## STAFF REPORT

SUBJECT: H 2020-0010

**Brody Square Final Plat**

### I. PROJECT DESCRIPTION

### B. Final Plat (date: 9/9/2020)

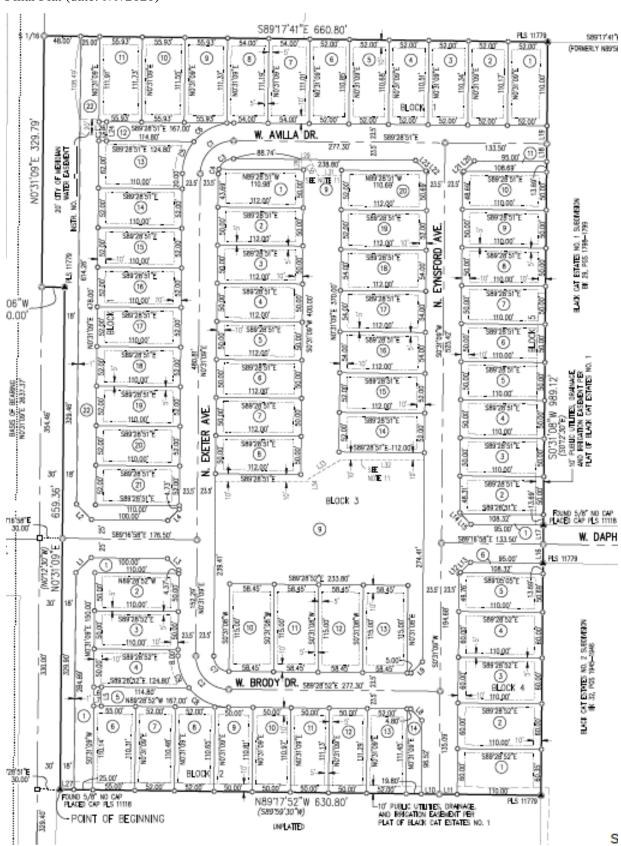
- 3. Prior to City Engineer signature on the final plat, the applicant shall provide documentation that ACHD has approved the vacation of Daphne St.
- 4. Prior to City Engineer signature on the final plat, the final plat prepared by Land Solutions, LLP, stamped by Clinton W. Hansen, dated: 9/9/2020, included in Section V.B shall be revised as follows:

- a. Add a note which restricts homes on Lots 8-10, Block 1 to one-story.
  - b. Note 2: Add dimensions to easement language. (5-feet each side required, and 10-feet to the the rear)

- c. Note 10: Add Development Agreement Instrument Number 2020-138110.
  - d. Note 12: Add ACHD License Agreement Instrument Number.
- 5. Prior to the City Engineer signature on the final plat, the landscape plan, prepared by Kimley Horn, dated 10/12/2020, included in Section V.D shall be revised to include a mitigation plan approved by the City Arborist which indicates the total number and caliper inches of trees proposed for removal and the total number of replacement trees proposed.

# D. Final Plat Landscape Plan (date: 10/12/2020)

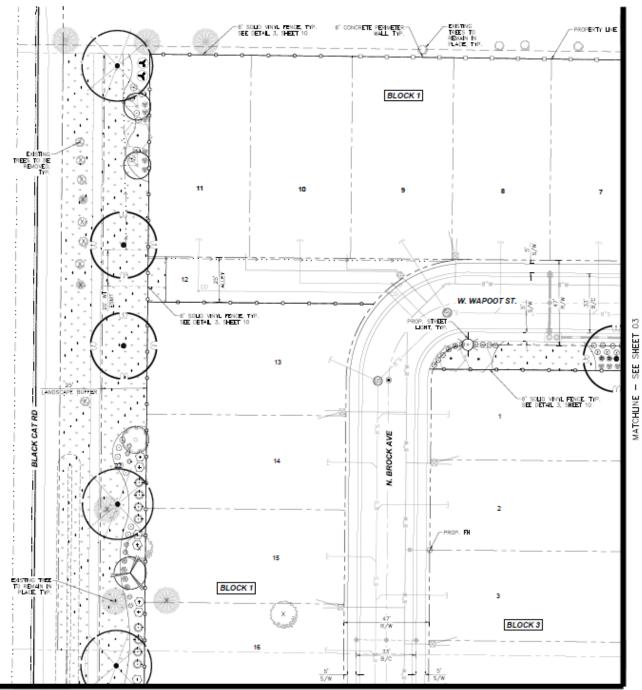
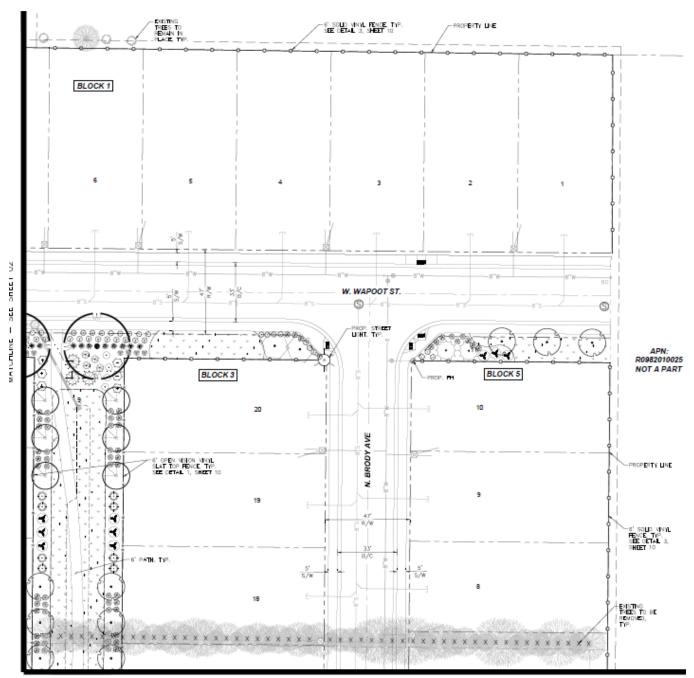
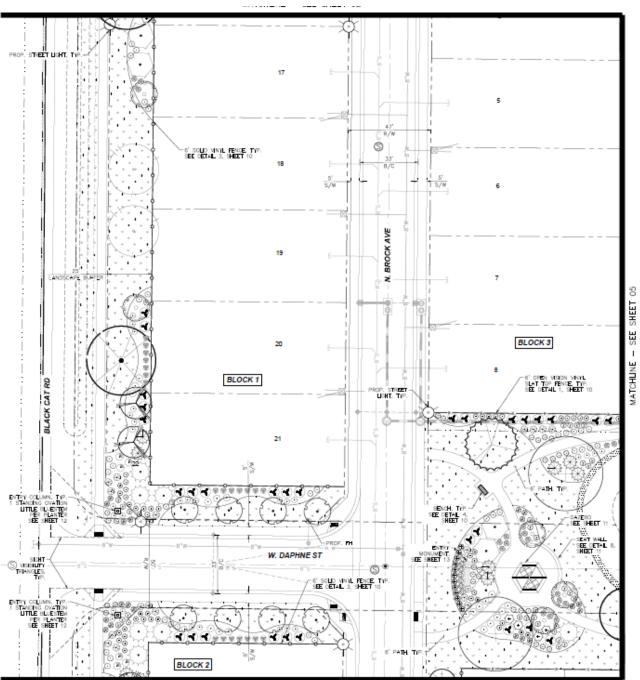
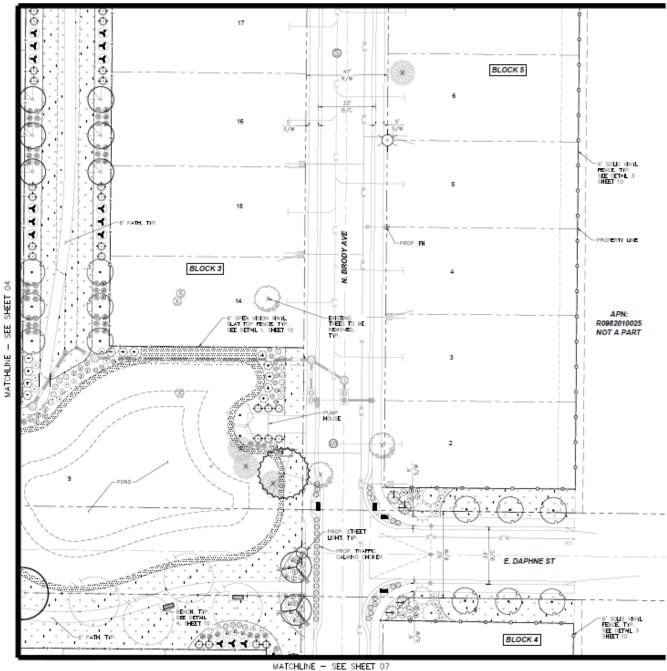
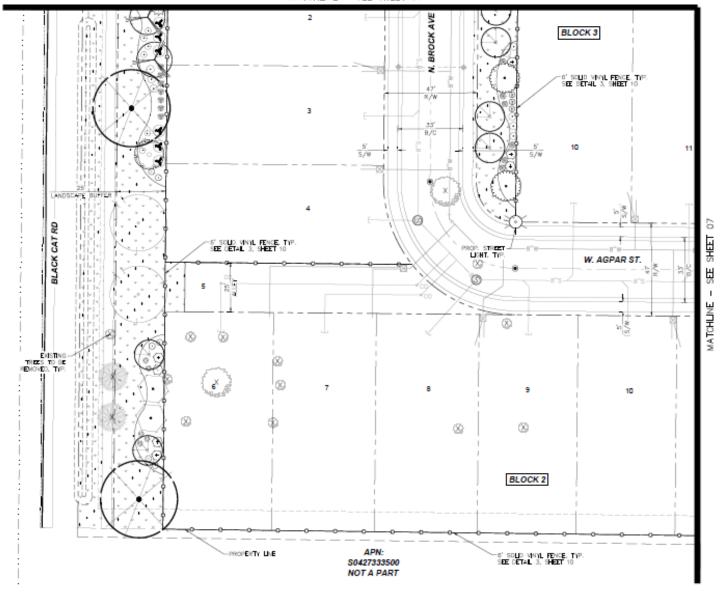
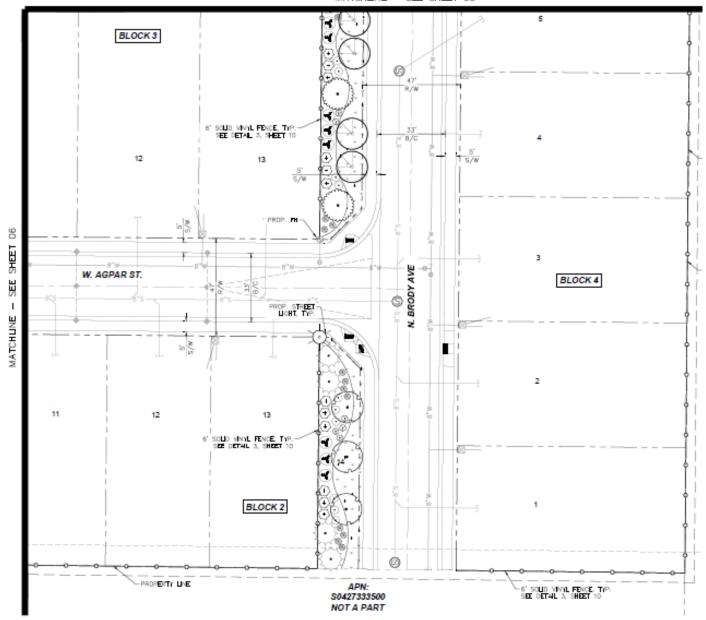
- 6. Prior to the City Engineer signature on the final plat, the landscape plan, prepared by Kimley Horn, dated 10/12/2020, included in Section V.D shall be revised to depict 5-foot wide landscaped buffers to separate the paved surface of the driveway from the fence on all common driveways which contain solid fencing per UDC 11-6C-3D.5.
